**BUILDING
INNOVATIONS
AUSTRALIA**

ADAPTABLE HOUSING INDICATIVE COMPLIANCE REPORT FOR DA LODGEMENT

**182-186 Gertrude Street,
North Gosford NSW 2250**

Prepared for: Linfield Group Pty Ltd
Project No.: PRO-08523-T7K4
Date: 11/10/2023
Status: Report Issue v1.0

Siting			
Item	Status	Item Description	References
		 <p>Second Floor Level Access from Street Frontage</p>	
		 <p>Third Floor Accessible Path of Travel</p>

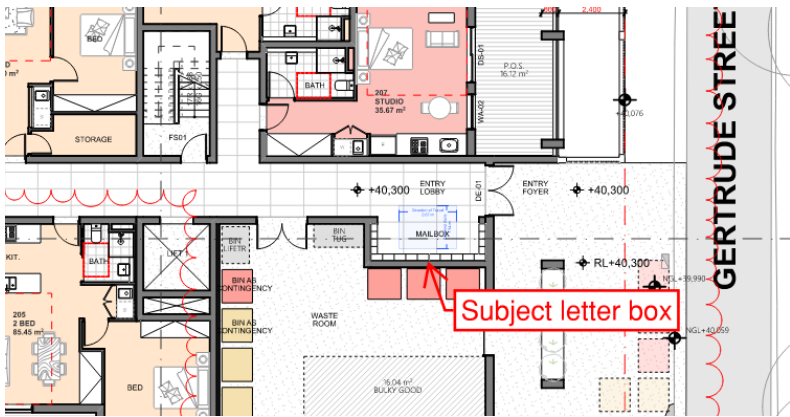
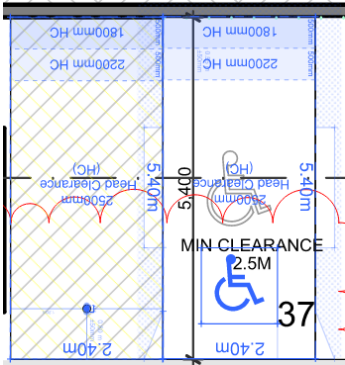
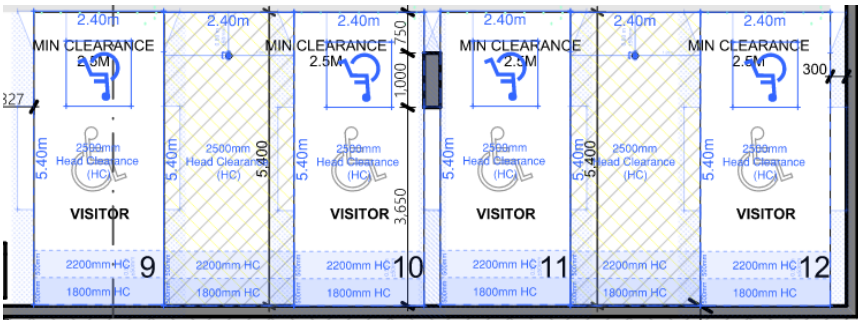
Siting			
Item	Status	Item Description	References
3	CRA	<p>A continuous path of travel from the street frontage and vehicle parking to entry complying with AS1428.1</p> <p><i>An accessible path of travel from the street frontage carparking area or drop-off point shall be provided to all adaptable housing units. As a minimum, this accessible path shall comply with AS 1428.1 and shall be continuous, slip-resistant, hard-surfaced and shall not incorporate any step, stairway or other impediment which would prevent it from being safely negotiated by people with disabilities. It is advisable for walkways to be provided with passing areas, as specified in AS 1428.2.</i></p> <p>A continuous path of travel from the vehicle parking and street frontage to entry complying with AS 1428.1 appears to be provided through the provision of a Clause E3.6 compliant lift, as illustrated below:</p>  <p>The diagram shows a plan view of the Basement Level 2 Carpark. A red dashed line outlines the carpark area. A blue shaded path of travel is shown, starting from the street frontage, passing through a lift shaft, and continuing through the carpark to the building entrance. The path is marked with blue arrows and includes a blue wheelchair icon. Various carpark spaces are numbered (e.g., 37, 38, 41, 42, 43, 44, 45, 46, 47). Other features like 'STAIRS', 'ELEVATOR', and 'TRAFFIC SIGNAL SYSTEM' are also labeled.</p>	<p>Clause 3.3.2 - Accessible Pathway</p>

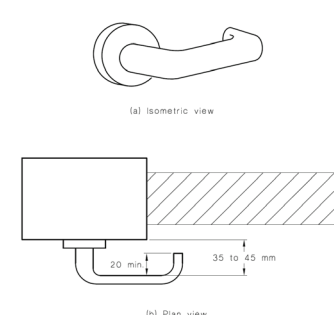
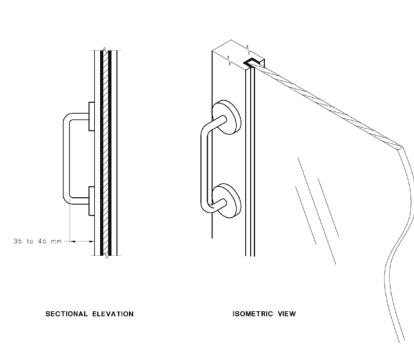
Item	Status	Item Description	References
		<p>As the requirement for the subject accessible entries to comply with AS 1428.2 is set by AS4299 and not by the Building Code of Australia (BCA) 2016, compliance with the requirements of the 1993 edition can be considered as sufficient.</p> <p>Below is a direct comparison of frontal-approach, swing-towards door circulation of 2001-edition dimension and 2009-edition dimensions, illustrating AS1428.1-2009 provides the same length as AS1428.2 based on 2001-edition, with greater latch-side circulation space, which is more important for independent access than hinge-side circulation space:</p>  <p>Although compliance with AS1428.1-1992 & AS1428.1-1993 is the minimum requirement for compliance with AS4299-1995, based on the above, this office considers compliance with AS1428.1-2009 required, and AS1428.2-1992 dimensions added to AS1428.1-2009 as highly desirable.</p> <p>The subject SOU entry doorways appear to comply with AS1428.1-2009 (green) and AS1428.2-1992 (orange) at post adaptation, as illustrated below:</p> <p>Units 307, 405 & 505:</p>

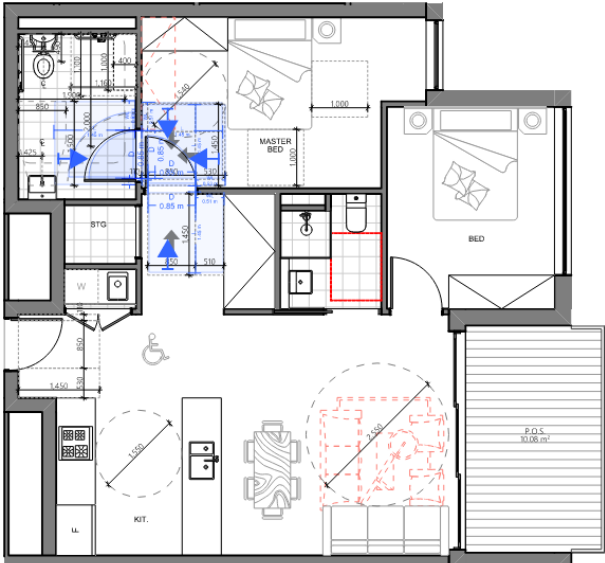
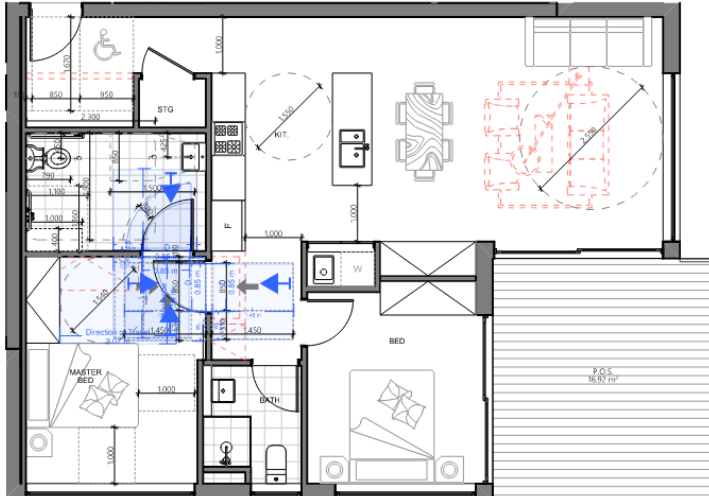
Accessible Entry			
Item	Status	Item Description	References
		<p>Units 608, 406 & 506:</p> 	
22	CRA	<p>Accessible Entry to be level (i.e 1:40 slope)</p> <p><i>Where the accessible entry door is exposed to the weather, it shall be provided with a landing outside the door with a maximum fall of 1:40 and a low threshold at the entry door to exclude water. The threshold shall allow for the smooth transition of a wheelchair (see Figure 4.1). The landing shall be of sufficient area to enable wheelchair manoeuvrability.</i></p>  <p>FIGURE 4.1 ENTRY LANDING</p> <p>RLs on plans indicate level accessible entry SOU doorways.</p>	Clause 4.3.2 - Landing
23	CRA	<p>Threshold to be low level</p> <p><i>Where the accessible entry door is exposed to the weather, it shall be provided with a landing outside the door with a maximum fall of 1:40 and a low threshold at the entry door to exclude water. The threshold shall allow for the smooth transition of a wheelchair (see Figure 4.1). The landing shall be of sufficient area to enable wheelchair manoeuvrability.</i></p> <p>Covered, level accessible entry SOU doorways with low or no threshold ramp within each unit entry doorway threshold as illustrated in Item 20.</p>	Clause 4.3.2 - Landing

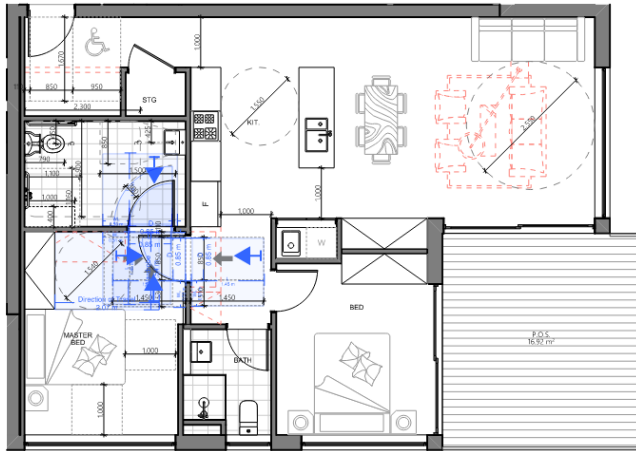
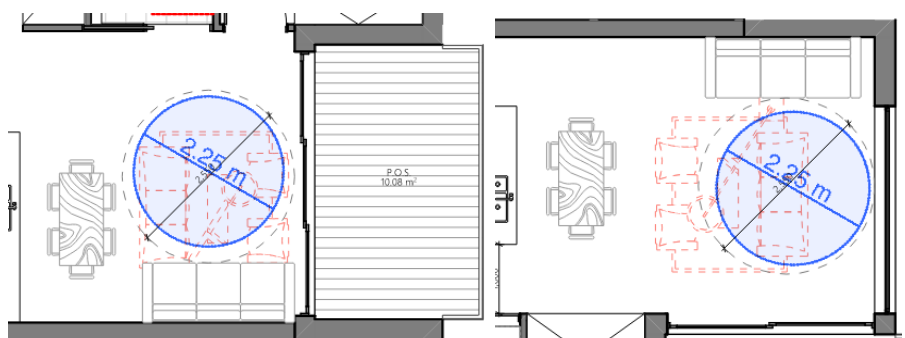
Item	Status	Item Description	References
33	CRA	<p>Internal Corridors to have min 1000mm width</p> <p><i>Internal corridors shall have a minimum width of 1000 mm. After adaptation, circulation spaces at doorways shall comply with AS 1428.1.</i></p> <p>Internal corridors of the subject units appear to comply with the required minimum 1000mm width throughout, as illustrated below:</p> <p>Units 307, 405 & 505:</p>  <p>Units 608, 406 & 506:</p> 	<p>Clause 4.3.7 - Internal Corridors</p>

Item	Status	Item Description	References
34	Complies	<p>Provision for compliance with AS 1428.1 for door approaches</p> <p>AS 1428.1-2009</p> <p>LEGEND: D = Clear opening of width of doorway L = Length W_H = Width—hinge side W_L = Width—latch side → = Direction of approach — = Circulation space</p> <p>DIMENSIONS IN MILLIMETRES</p> <p>FIGURE 31 (in part) CIRCULATION SPACES AT DOORWAYS WITH SWINGING DOORS</p> <p>58</p> <p>LEGEND: D = Clear opening of width of doorway L = Length W_H = Width—hinge side W_L = Width—latch side → = Direction of approach — = Circulation space</p> <p>DIMENSIONS IN MILLIMETRES</p> <p>FIGURE 31 (in part) CIRCULATION SPACES AT DOORWAYS WITH SWINGING DOORS</p> <p>59</p> <p>LEGEND: D = Clear opening of width of doorway L = Length W_H = Width—hinge side W_L = Width—latch side → = Direction of approach — = Circulation space</p> <p>DIMENSIONS IN MILLIMETRES</p> <p>FIGURE 31 (in part) CIRCULATION SPACES AT DOORWAYS WITH SWINGING DOORS</p> <p>AS 1428.1-2009</p> <p>59</p> <p>LEGEND: D = Clear opening of width of doorway L = Length W_H = Width—hinge side W_L = Width—latch side → = Direction of approach — = Circulation space</p> <p>DIMENSIONS IN MILLIMETRES</p> <p>FIGURE 31 (in part) CIRCULATION SPACES AT DOORWAYS WITH SWINGING DOORS</p>	Clause 4.3.7 - Internal Corridors

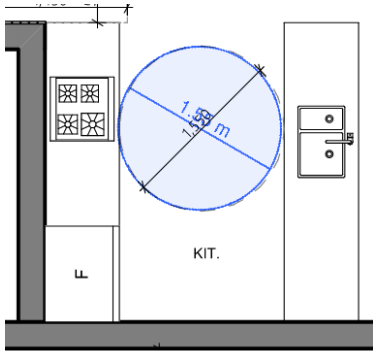
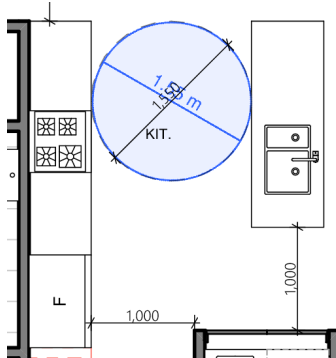
<p>Internal corridors shall have a minimum width of 1000 mm. After adaptation, circulation spaces at doorways shall comply with AS 1428.1.</p> <p>Provision for doorway approach circulation spaces for the main toilet and common facilities to comply with AS 1428.1-2009 with minimum 820mm clear door width as allowed by Item 32 for the subject units appear to be provided at post-adaptation as illustrated below:</p> <p>Units 307, 405 & 505:</p>

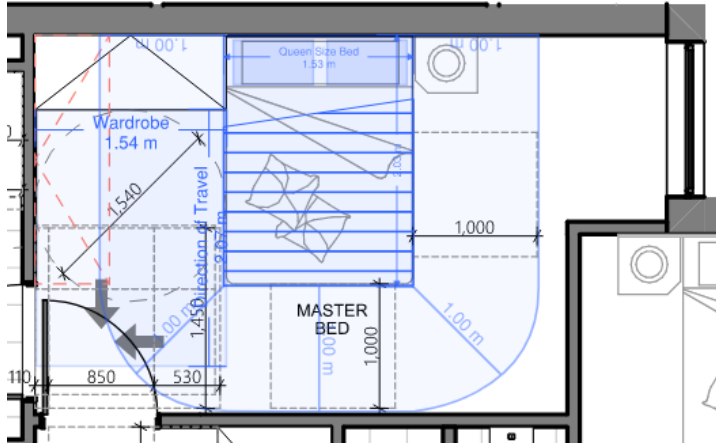
Kitchen			
Item	Status	Item Description	References
44	CRA	<p>Provision for benches planned to include at least one work surface of 800mm length, adjustable in height from 750mm to 850mm or replaceable (Figure 4.8 from AS 4299-1995)</p>  <p>At least one section of the work surface, not less than 800 mm in length, should comply with the following:</p> <ul style="list-style-type: none"> (a) The work surface should be adjustable or replaceable as a unit at variable heights within the range 750 mm to 850 mm above the finished floor surface. (See Figure 4.8(b).) (b) Base cabinets, if provided, should be removable over the full 800 mm length of the work surface. The finished floor shall extend under the work surface to the wall. (c) The required clear floor space of 1500 mm x 820 mm should allow a forward approach to the work surface. No more than 500 mm of this clear floor space should extend beneath the work surface. (See Figure 4.8(c).) <p>As illustrated below, the subject units have provision for not less than one worksurface:</p> 	Clause 4.5.5 - Work Surfaces

45	CRA	<p>Refrigerator adjacent to work surface</p> <p>At least one section of the work surface, not less than 800 mm in length, should comply with the following:</p> <ul style="list-style-type: none"> (a) The work surface should be adjustable or replaceable as a unit at variable heights within the range 750 mm to 850 mm above the finished floor surface. (See Figure 4.8(b).) (b) Base cabinets, if provided, should be removable over the full 800 mm length of the work surface. The finished floor shall extend under the work surface to the wall. (c) The required clear floor space of 1500 mm x 820 mm should allow a forward approach to the work surface. No more than 500 mm of this clear floor space should extend beneath the work surface. (See Figure 4.8(c).) <p>The subject unit appears to have provision for a designated 800mm work surface adjacent the refrigerator; as indicated in Item 44.</p>	Clause 4.5.5 - Work Surfaces

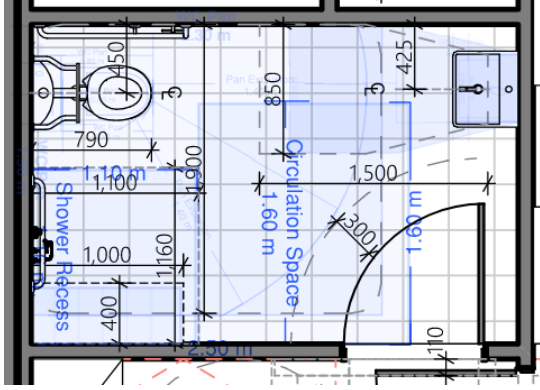
Main Bedroom			
Item	Status	Item Description	References
62	CRA	<p>At least one bedroom of area sufficient to accommodate queen size bed and wardrobe and circulation space requirements of AS 1428.2</p> <p><i>At least one bedroom shall be capable of accommodating a queen size bed and a wardrobe and the circulation space requirements of AS 1428.2 clear of wardrobe fixtures.</i></p> <p>Provision of a queen size bed, not less than 1000mm circulation space on both sides and foot of bed, and provision of a wardrobe and space for a 180° turn in front of the wardrobe circulation spaces are provided for the subject units at post-adaptation, as illustrated below:</p> <p>Units 307, 405 & 505:</p>  <p>Units 608, 406 & 506:</p> 	Clause 4.6.1 - Bedroom Areas

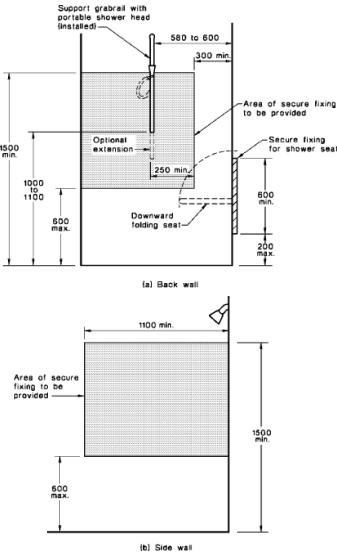
Bathroom			
Item	Status	Item Description	References
75	CRA	<p>Provision for bathroom area to comply with AS 1428.1</p> <p><i>All sanitary facilities and components shall be adaptable, at minimum cost, to potentially comply with AS 1428.1 as a minimum, and preferably with AS 1428.2.</i></p> <p><i>NOTE: The required circulation spaces at doors and around WC pans, washbasins and showers shall be able to be provided without major plumbing changes. The WC pan should either be located in the after-adaptation location initially or be fitted with a P trap. In addition, items like toilet paper dispensers and WC flushing controls shall comply with AS 1428.1. Because of the difficulty in moving some of these items after they have been initially installed, it is desirable that they should comply with AS 1428.1 from the outset.</i></p>  <p>The technical drawings illustrate various bathroom configurations and their required dimensions for accessibility. Key features include:</p> <ul style="list-style-type: none">Top Left: Plan view of a bathroom with a shower, toilet, and washbasin. Dimensions include 2300mm total width, 1900mm total depth, and specific clearances for the shower (1100mm width, 1600mm depth) and toilet (700mm width, 800mm depth).Top Right: Plan view of a bathroom with a shower, toilet, and washbasin. Dimensions include 2350mm total width, 1900mm total depth, and specific clearances for the shower (1100mm width, 1600mm depth) and toilet (700mm width, 800mm depth).Middle Left: Plan view of a bathroom with a toilet, washbasin, and shower. Dimensions include 1900mm total width, 1400mm total depth, and specific clearances for the toilet (450mm width, 600mm depth) and washbasin (450mm width, 600mm depth).Middle Right: Section view of a toilet and washbasin. Dimensions include 425mm total width, 450mm total depth, and specific clearances for the toilet (425mm width, 450mm depth) and washbasin (425mm width, 450mm depth).Bottom Left: Plan view of a bathroom with a toilet, washbasin, and shower. Dimensions include 1900mm total width, 1400mm total depth, and specific clearances for the toilet (450mm width, 600mm depth) and washbasin (450mm width, 600mm depth).Bottom Middle: Plan view of a bathroom with a toilet, washbasin, and shower. Dimensions include 1900mm total width, 1400mm total depth, and specific clearances for the toilet (450mm width, 600mm depth) and washbasin (450mm width, 600mm depth).Bottom Right: Plan view of a bathroom with a toilet, washbasin, and shower. Dimensions include 1900mm total width, 1400mm total depth, and specific clearances for the toilet (450mm width, 600mm depth) and washbasin (450mm width, 600mm depth).	Clause 4.4.1 - General

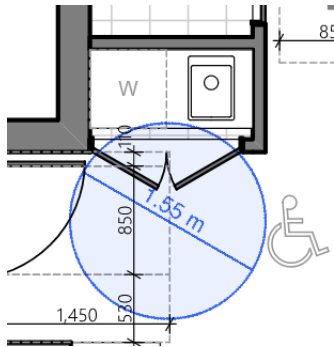
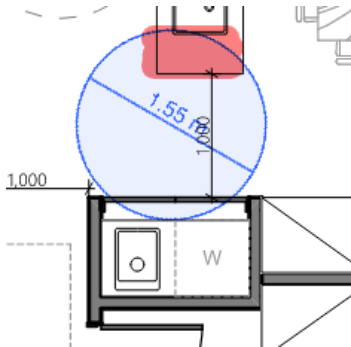
Item	Status	Item Description	References
92	CRA	<p>Provision of either 'visitable toilet' or accessible toilet</p> <p><i>Each housing unit shall be provided with either a visitable toilet or an accessible toilet. Where a separate toilet and bathroom are used with the intention of future unification, the WC pan shall initially be positioned at the correct distance from any fixed walls. Refer to Figure 4.3.</i></p> <div data-bbox="435 598 1117 969"><p>(a) Side view</p><p>(b) Front view</p></div> <p>NOTES:</p> <ol style="list-style-type: none">1 For the purpose of dimensioning, the front of the WC pan has been taken as the datum plane.2 The dimension of 800 mm from the front of the WC pan to the wall is a critical dimension.3 A back support at 600 mm from the front of the pan is important. This supports people who are paralysed from the chest down. The back support may be a cistern or a continuous grab rail and toilet lid. <p>DIMENSIONS IN MILLIMETRES</p> <p>FIGURE 4.3 LOCATION OF WC PAN</p> <p>Provision for this item appears to be indicated on the post-adaption plans as illustrated in Item 75.</p> <p>In addition, provision for a visitable toilet pre-adaptation also appears to be made for the subject units as illustrated below:</p> <p>Units 307, 405 & 505:</p> <div data-bbox="635 1491 922 1872"></div>	Clause 4.4.3 - Toilet
